Access Compliance Report

Public Rights-of-Way

(Curb Ramps)

Intersection ID: 50341	Main Street: SCONE_PALACE_CT	Cross Street: CASTLECOVE_RD	Location: NE
ADA ID: 8ED7C27DD01F	Ramp Type: Perpendicular Diagonal	Initial Pass/Fail: Fail	Overall Compliance: No
		Severity Score: 12.5

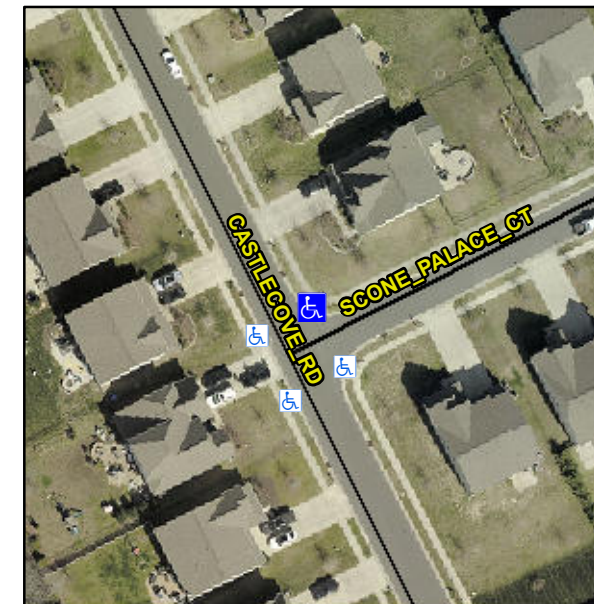
R304.2.2

Compliance	Description	Data	Compliance	Description	Data
N/A	Ramp Length (in)	48.0	No	Ramp Slope (%)	9.4
Yes	Ramp Width (in)	48.0	Yes	Ramp XSlope (%)	1.6
N/A	Flare Type LT	N/A	N/A	Flare Type RT	N/A
N/A	Flare Slope LT (%)	N/A	N/A	Flare Slope RT (%)	N/A
N/A	Flare Traversable LT?	N/A	N/A	Flare Traversable RT?	N/A
N/A	Landing Length (in)	N/A	N/A	DWS Provided?	N/A
N/A	Landing Width (in)	N/A	N/A	DWS Contrast?	N/A
N/A	Landing Slope (%)	N/A	N/A	DWS Length (in)	N/A
N/A	Landing X Slope (%)	N/A	N/A	DWS Full Width?	N/A
N/A	Landing Curb? (Y/N)	N/A	N/A	DWS Offset (in)	N/A
N/A	Shared Landing?	N/A			
N/A	Gutter Ponding?	N/A	N/A	Gutter Slope (%)	N/A
N/A	Gutter Lip Ht (in)	N/A	N/A	Gutter X Slope (%)	N/A
N/A	Painted X Walk1?	No	N/A	Painted X Walk2?	No
	X Walk 1 Direction	To SW		X Walk 2 Direction	To SE
N/A	X Walk 1 Width (in)	N/A	N/A	X Walk 2 Width (in)	N/A
	X Walk 1 Slope (%)	3.0		X Walk 2 Slope (%)	0.6
	X Walk 1 X Slope (%)	0.9		X Walk 2 X Slope (%)	1.2

Remove & Replace Curb Ramp With Two New Directional Ramps or Equivalent.
